**ADDENDUM No. 2**

Date: June 5, 2026

Project: Hector International Airport  
Terminal Apron Reconstruction – Phase 2

**C-052R**

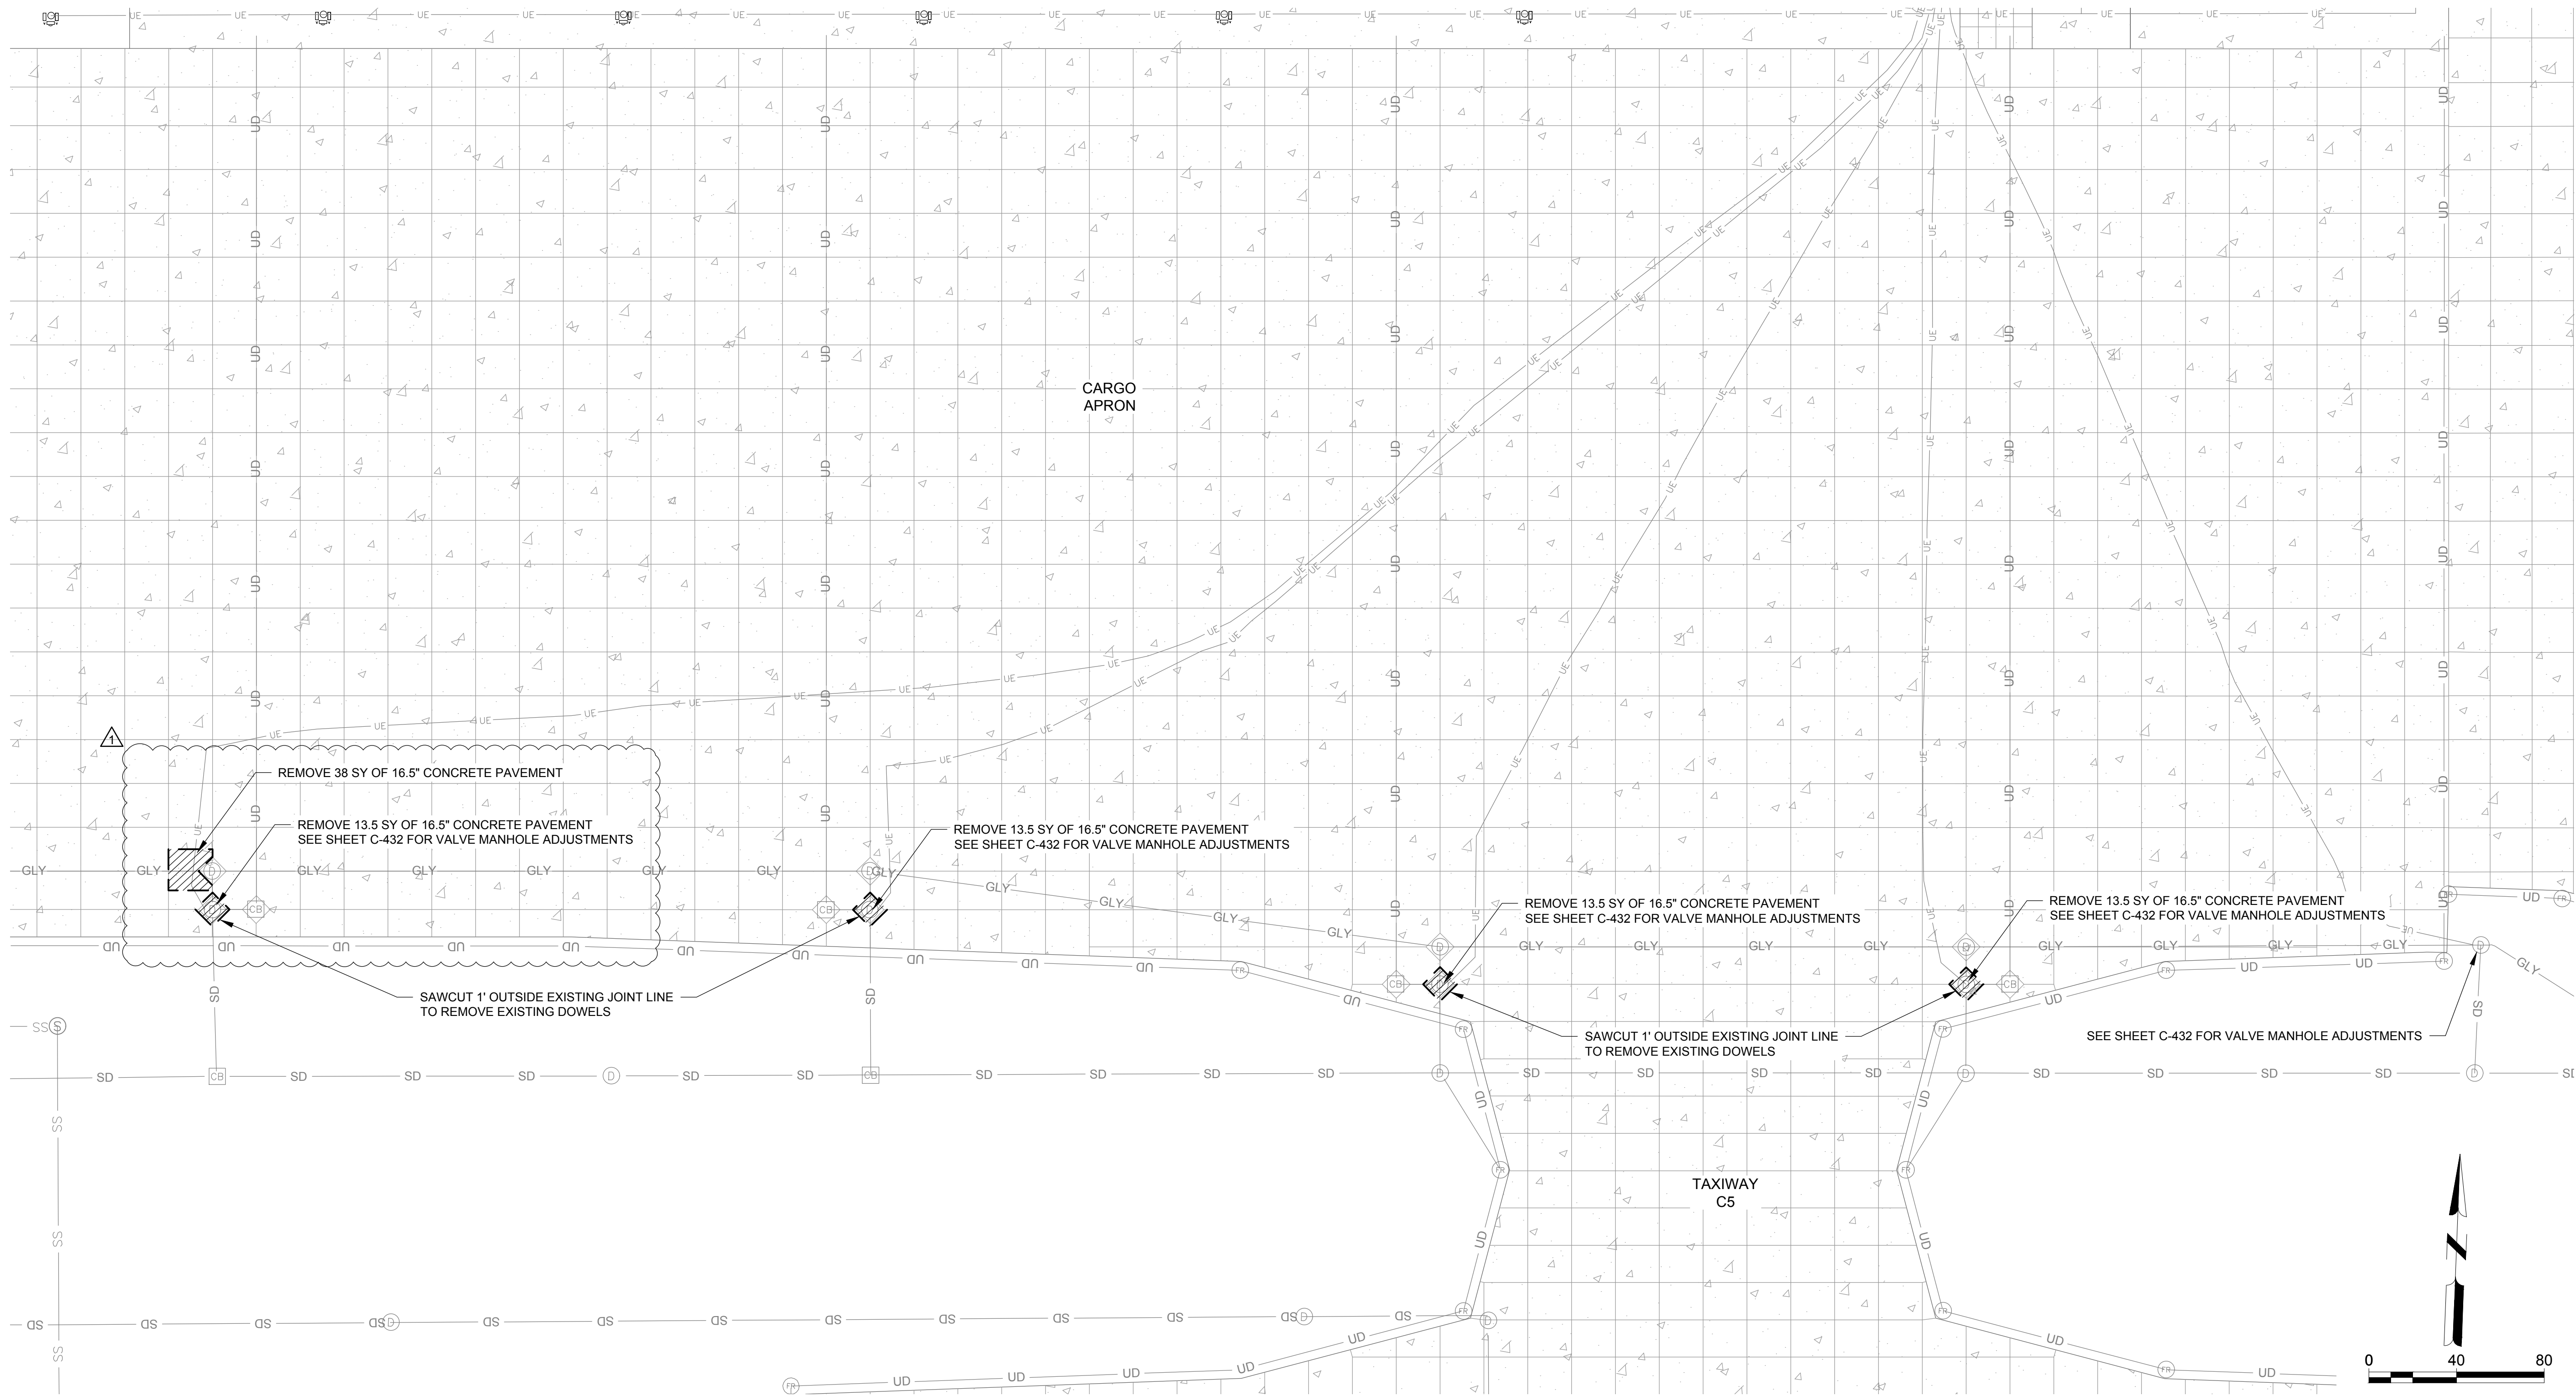
### **3. Sheet C-052 DEMOLITION PLAN – CARGO APRON**

- I. Add additional concrete pavement removal for gate valve installation

**C-432R**

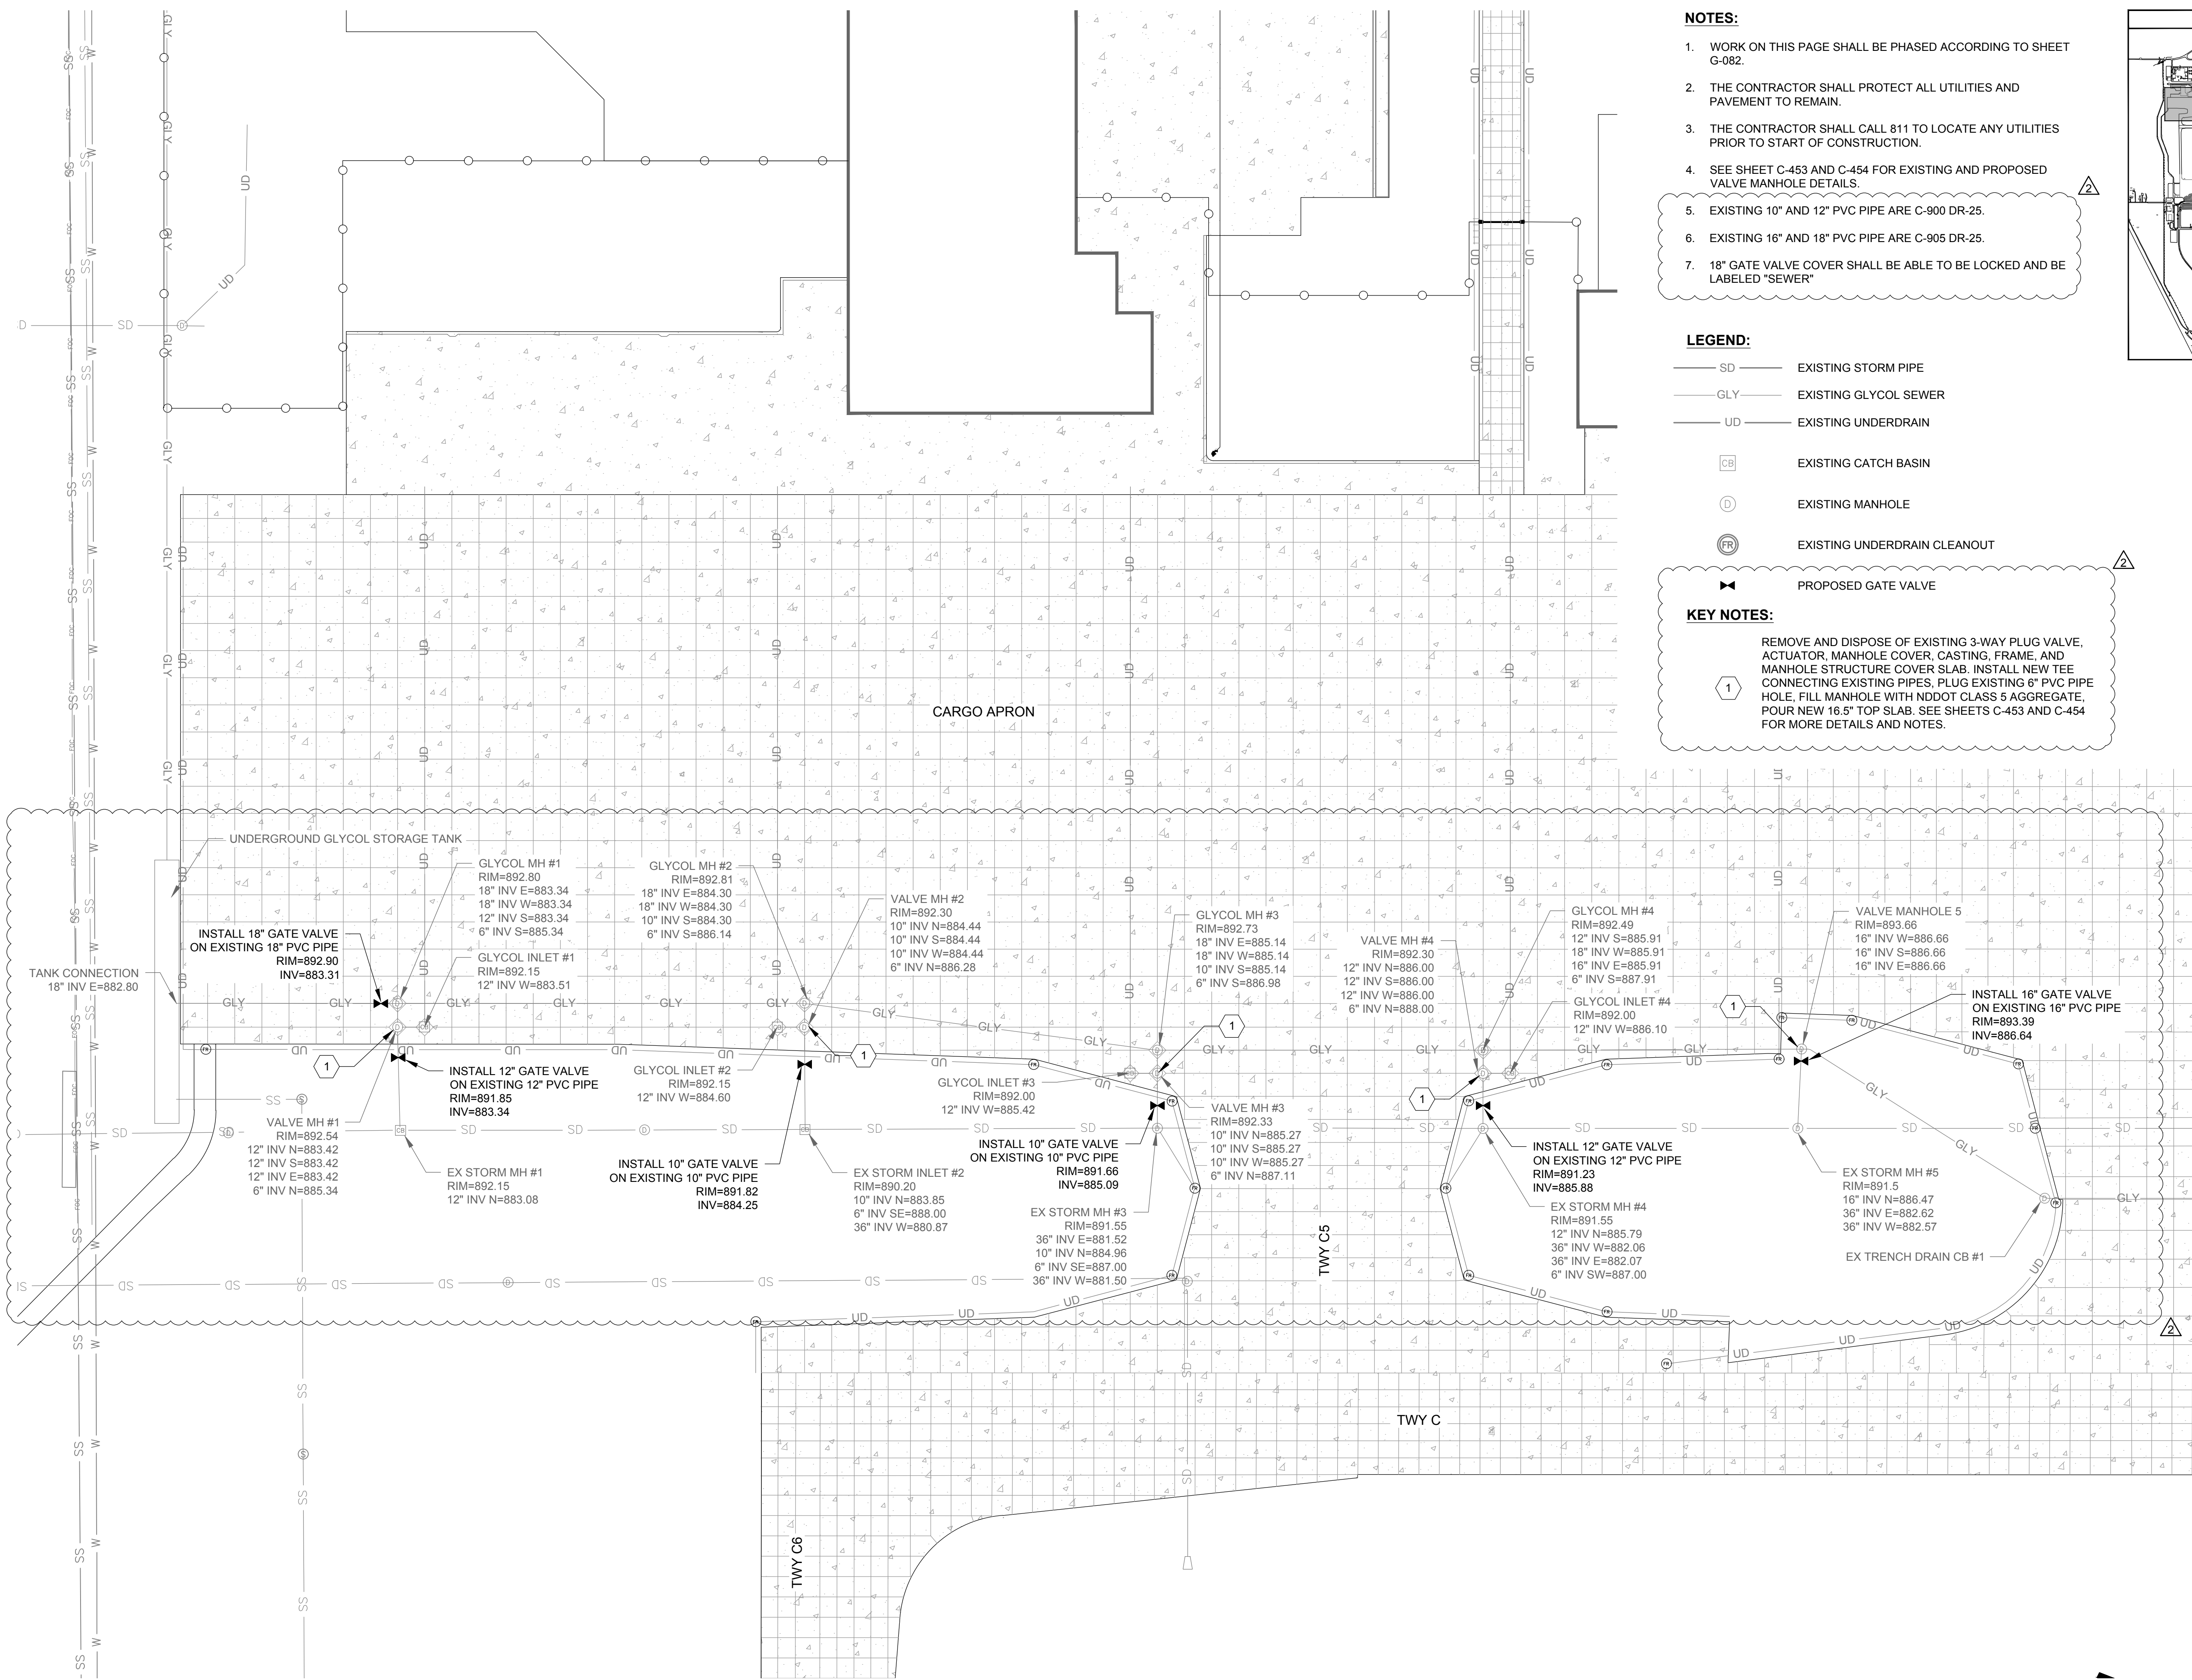
### **4. Sheet C-432 GLYCOL SEWER VALVE MANHOLE ADJUSTMENTS**

- I. Add gate valves to PVC storm and glycol lines
- II. Add notes 5, 6, and 7
- III. Revise Legend and Key Note 1
